# SKYLINE AT LORSON RANCH

## PLANNED UNIT DEVELOPMENT AND PRELIMINARY PLAN

EL PASO COUNTY, CO SECOND SUBMITTAL: JUNE 09, 2021

PCD FILE NO.: PUDSP212

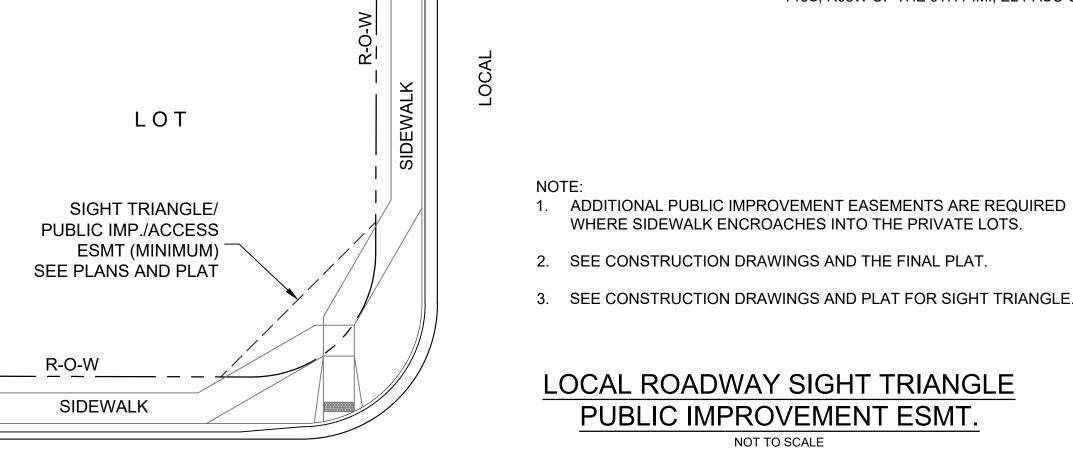
#### DIMENSIONAL STANDARDS AND GUIDELINES (PUMPSTATION) landscape Grayling Dr and between SF DIMENSIONAL STANDARDS FOR PUMPSTATION (TRACT D) ⊢oก north side fencing if higher MAXIMUM IMPERVIOUS COVERAGE: 80% larger than 6 feet fencing detail MAXIMUM STRUCTURAL HEIGHT: FORTY FIVE FEET (45'). BUILDING/ LANDSCAPE SETBACK REQUIREMENTS:/ (industrial) chain link A. FRONT YARD: TWENTY FEET (20') this needs to be very B SIDE YARD: TWENTY FEET (201) C. REAR YARD: TWENTY FEET (20') DEVELOPMENT STANDARDS AND GUIDELINES (PUMPSTATION)

PRINCIPAL USES add generator, maintenance bldg, max sf of building, above ground facility, ALLOWED USES INCLUDE: UTILITIES, ACCESS DRIVE, STR ALLOWED USES INCLUDED WITH THE SACRESS DRIVE STRUCTURES, FENCING, WIDEFIELD WATER AND SANITATION DISTRICT FACILITIES, AND \*PRINCIPAL USES ARE SUBJECT TO THE REQUIREMENTS ( \*PRINCIPAL USES ARE SUBJECT TO THE REQUIREMENTS OF THE EL PASO COUNTY LAND DEVELOPMENT, AS AMENDED

JASON GET THESE DETAILS FROM GWEN AT JDS HYDRO (WE DISCUSSED WITH HER I THE EA FOR FACILITY)

COVER SHEET, NOTES, SITE **DETAILS & DATA** CHART

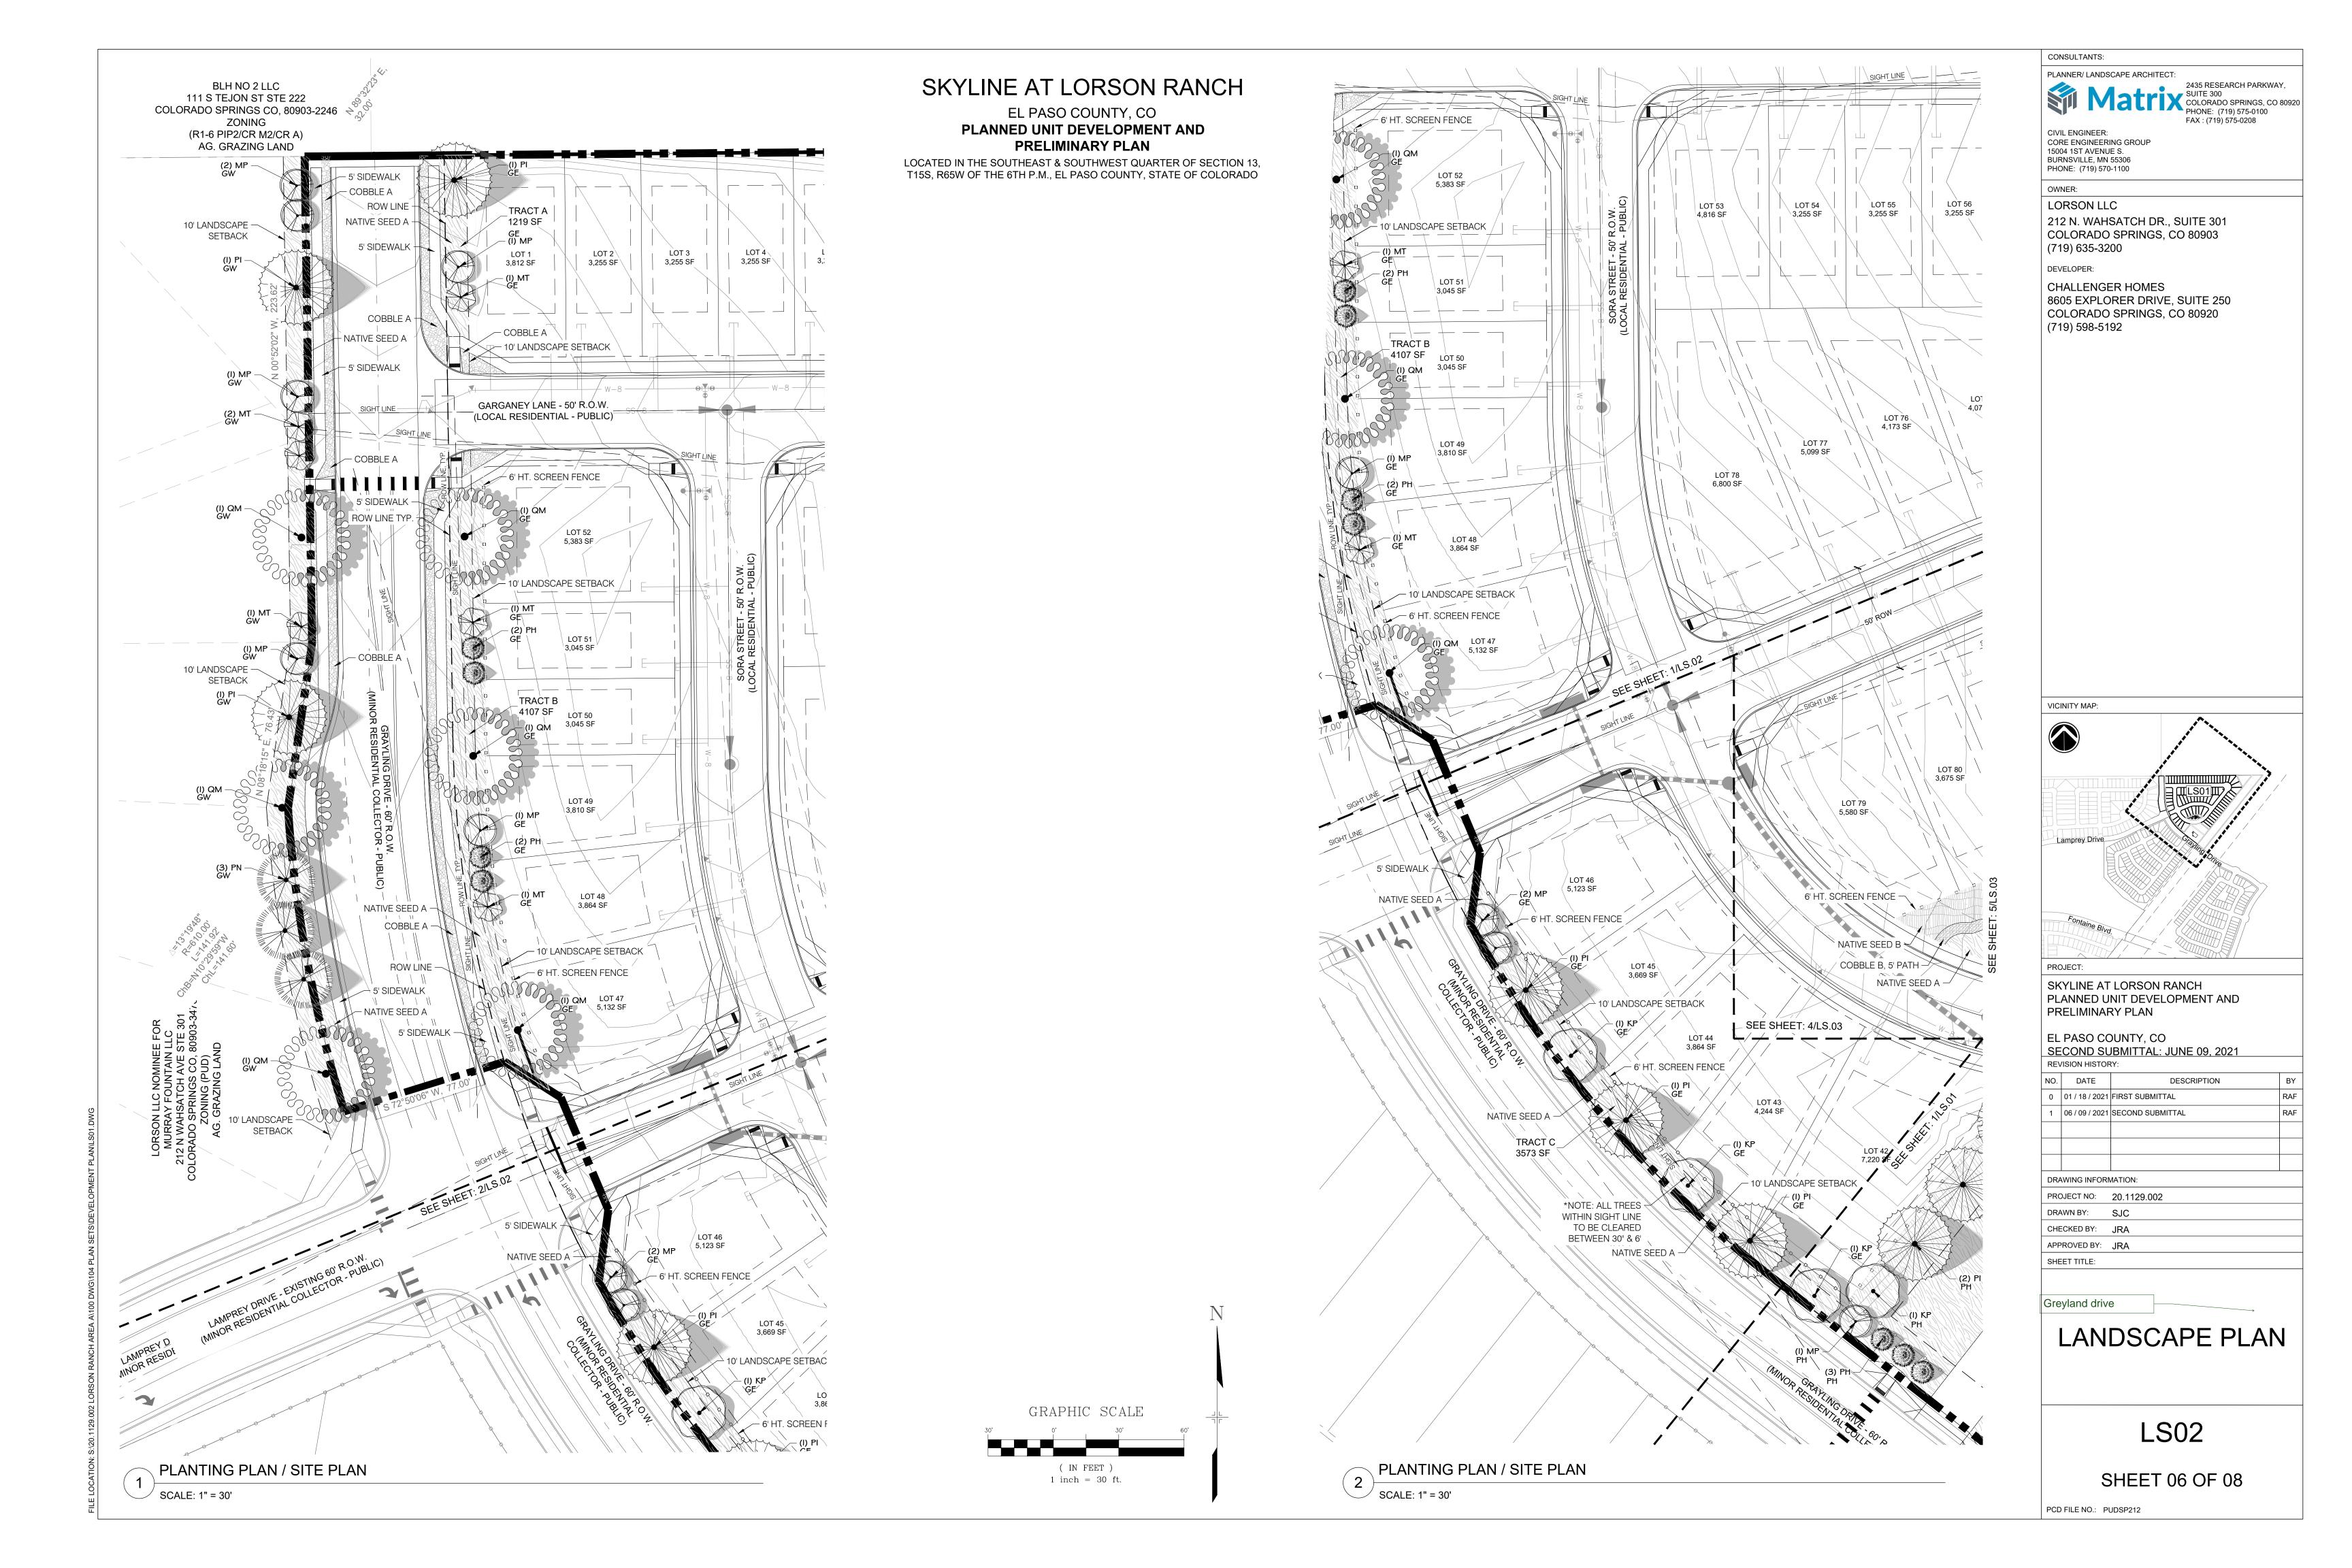
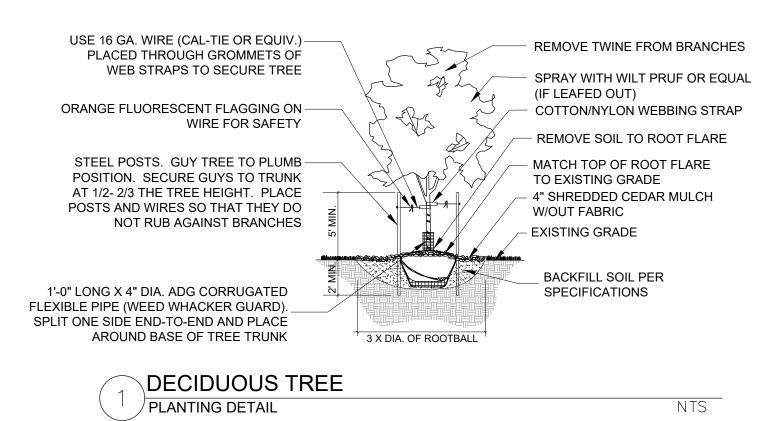
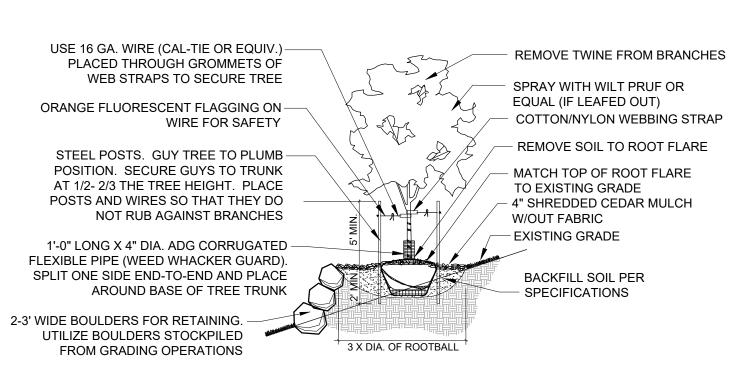
> buffer between SF and industrial 15 feet trees \_\_\_\_add to

Utility Tract Landscape plan sheet
